SAN FRANCISCO PLANNING DEPARTMENT

Discretionary Review Abbreviated Analysis

Date: September 6, 2012
Case No.: **2011.1050DD**
Project Address: **2807 CLAY STREET**
Permit Application: 201102049665
Zoning: RH-3 [Residential House, Three-Family]
40-X Height and Bulk District
Block/Lot: 1003/036
Project Sponsor: Butler Armsden Architects
2849 California Street
San Francisco, CA 94115
Staff Contact: Aaron Starr – (415) 588-6362
aaron.starr@sfgov.org
Recommendation: **Do not take DR and approve as proposed**

11.10507

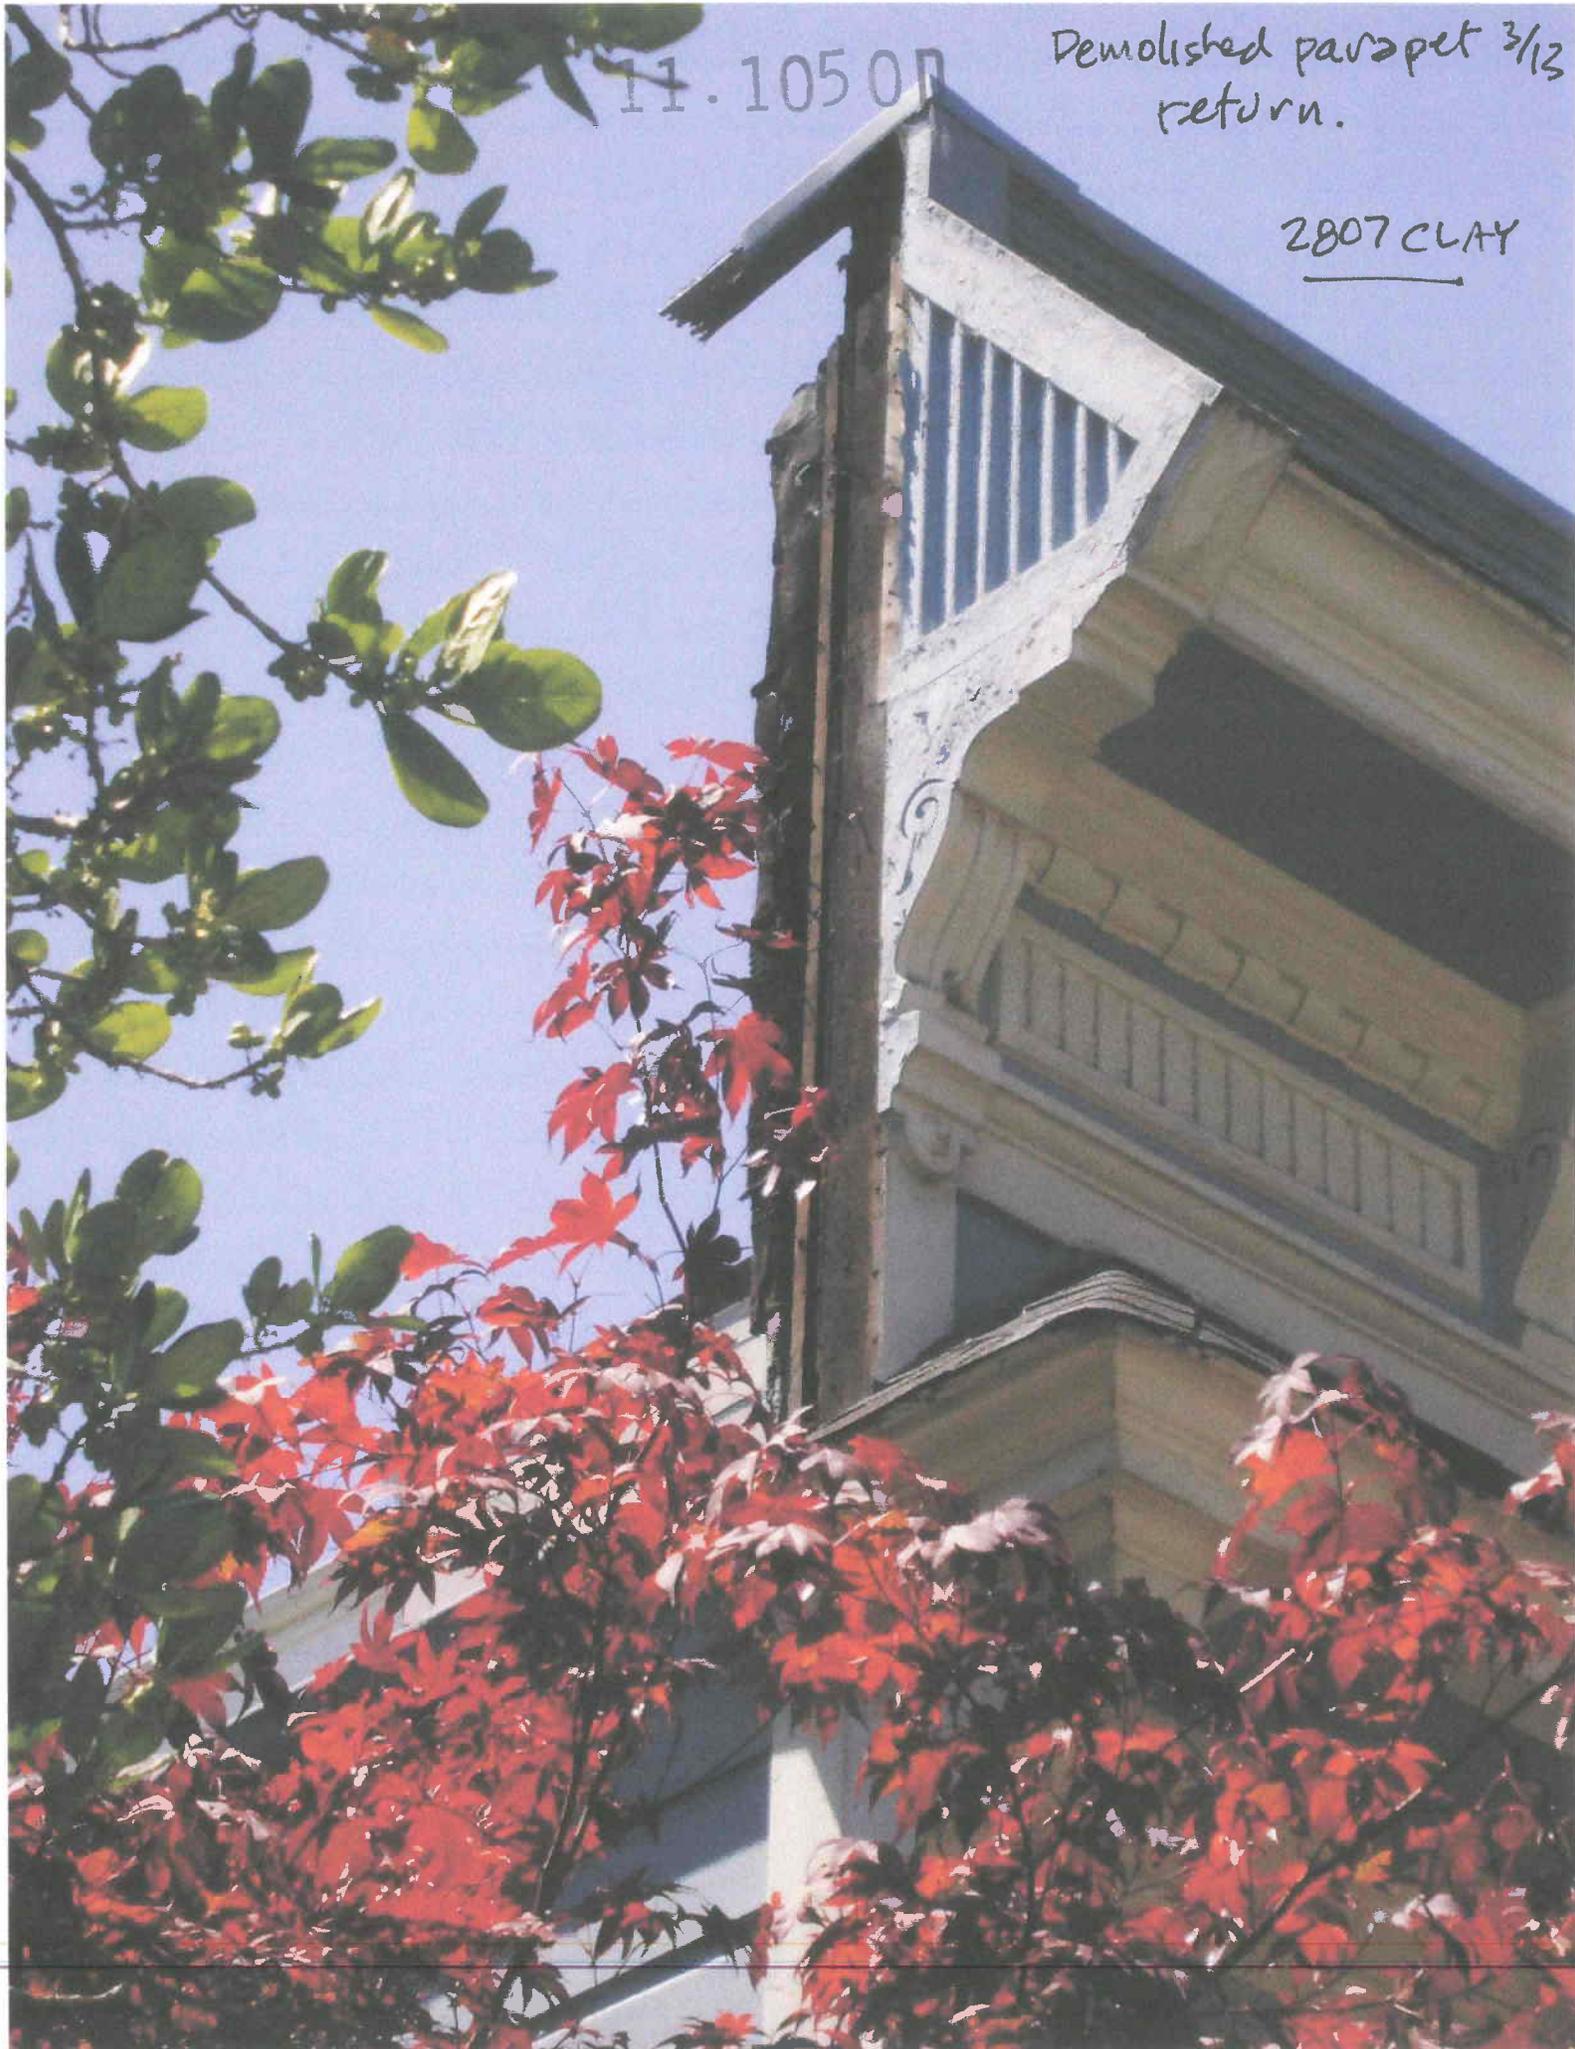
Demolished parapet 3/13
return.

11/13

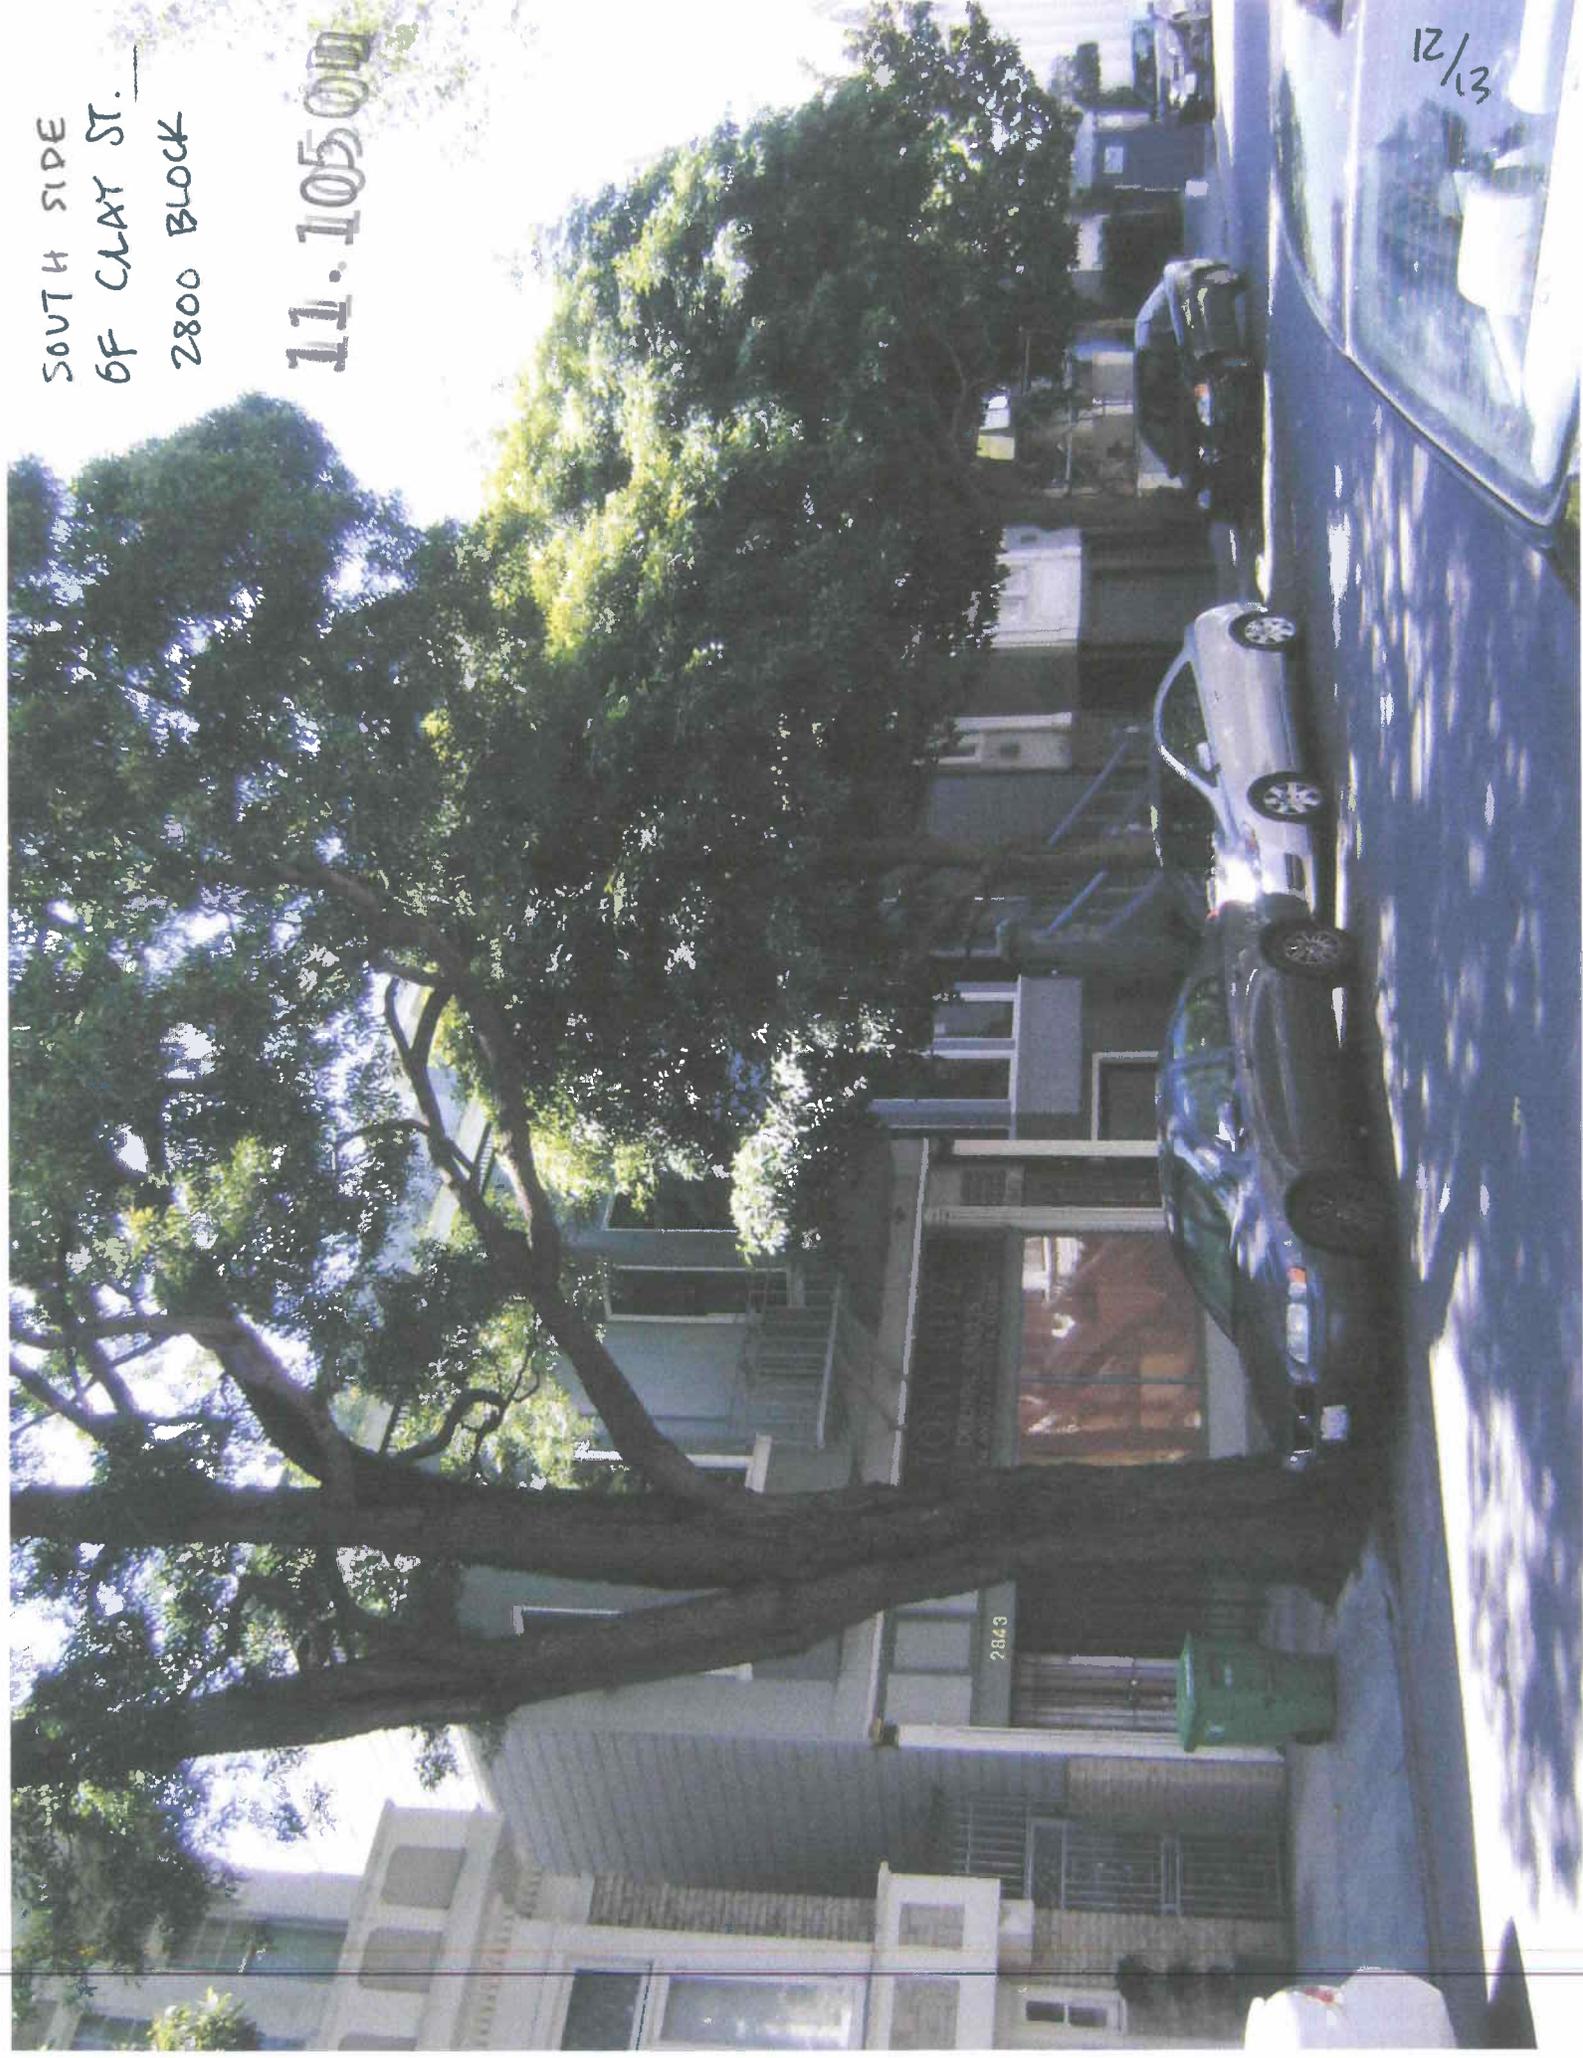
THIS IS NOT NOTED ON
THE BNV. REVIEW CHECKLIST
